TRANSMITTAL COVER SHEET

DATE: 21 June, 2024
TO: ALL PLAN HOLDERS OF RECORD
FROM: HUNTER SWATEK, AIA, PROJECT MANAGER
PROJECT: RAINBOW CITY RECREATION CENTER
GMC PROJECT NO. ABHM230021
RE: ADDENDUM NO. 3 AND
ACKNOWLEDGEMENT OF RECEIPT OF ADDENDUM NO. 3

ADDENDUM NUMBER 03

**PROJECT: RAINBOW CITY RECREATION CENTER
GM&C PROJECT NO. ABHM230021**

DRAWN BY: _____
CHECKED BY: _____

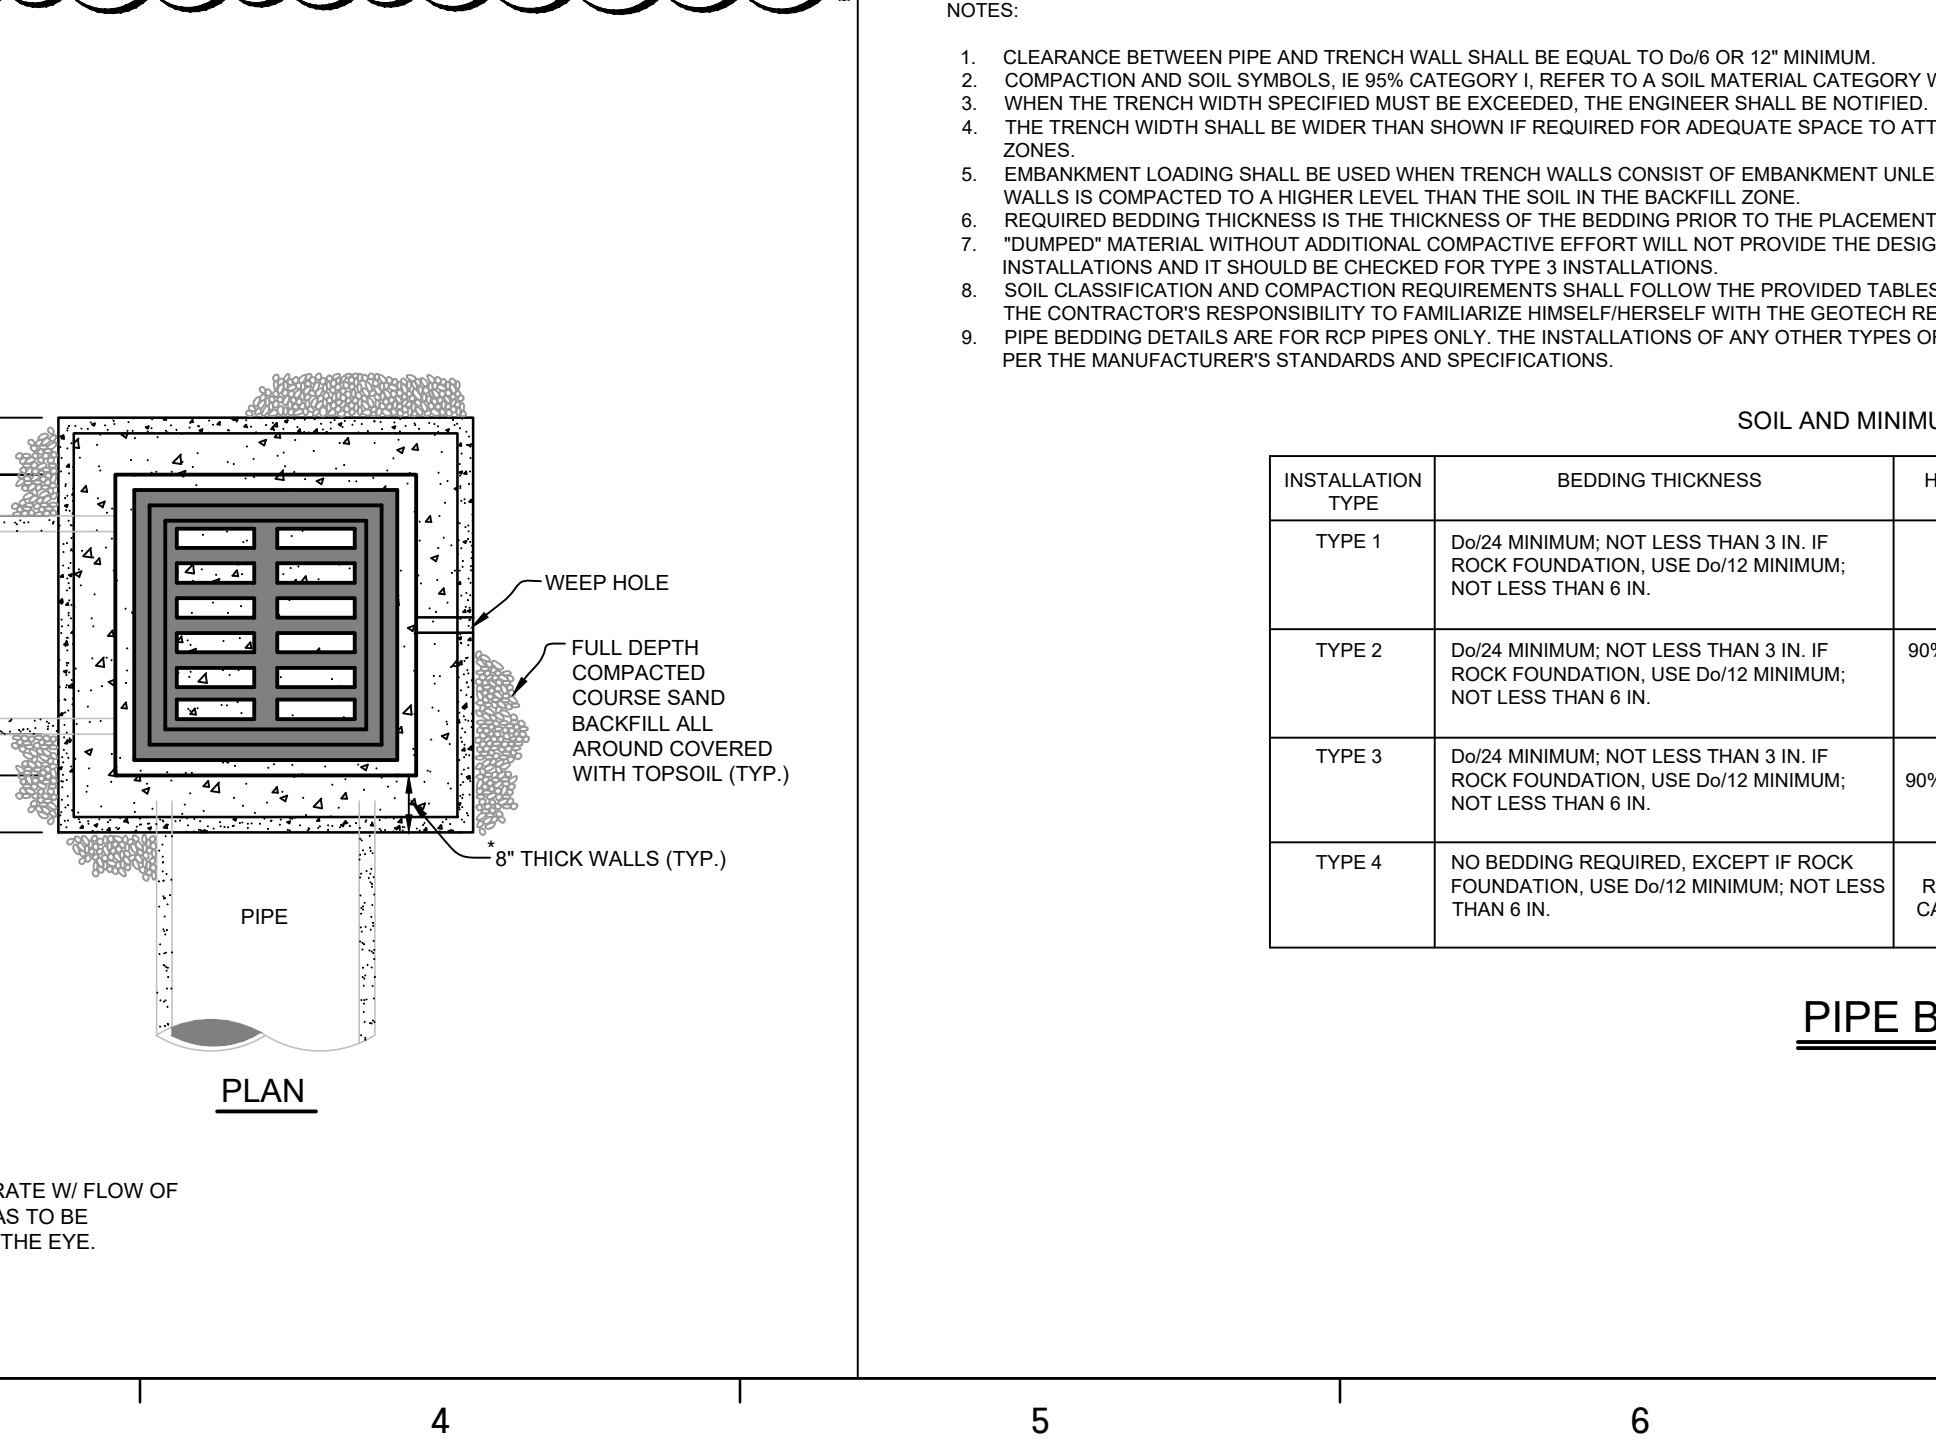
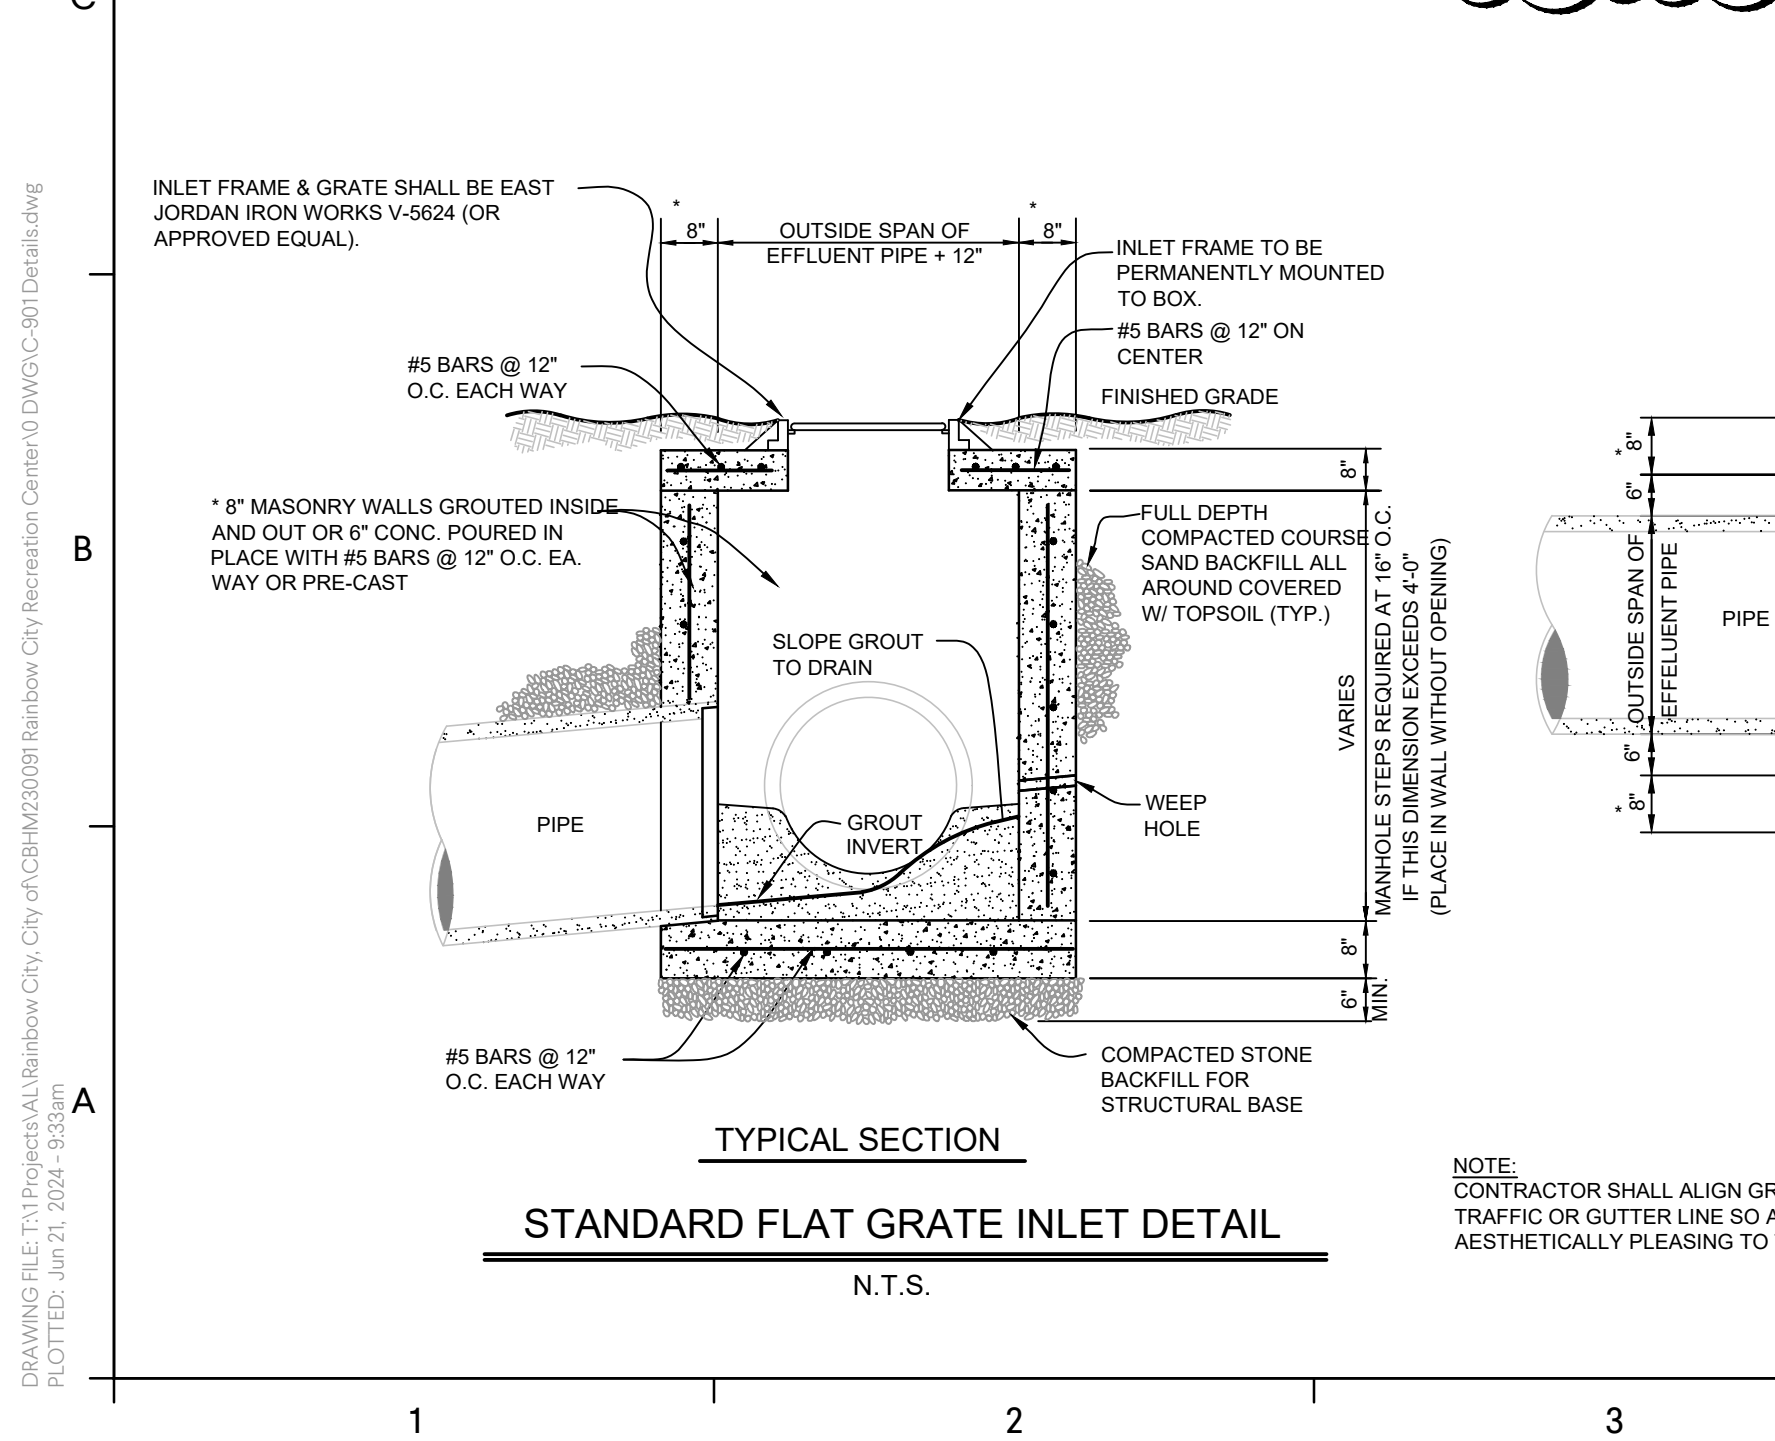
- a. REVISED Construction exit pad
 - b. REVISED Outlet protection
 - c. REVISED silt fence extents
 - d. REVISED Erosion control extents
- M. **C-602** – Alternate Erosion and Sediment Control plan

- a. REVISED Notes and measures
- N. **C-903** – Storm Drainage Details
 - a. REVISED Outlet Control Detail
 - b. ADDED Detail for outlet protection and concrete encasement
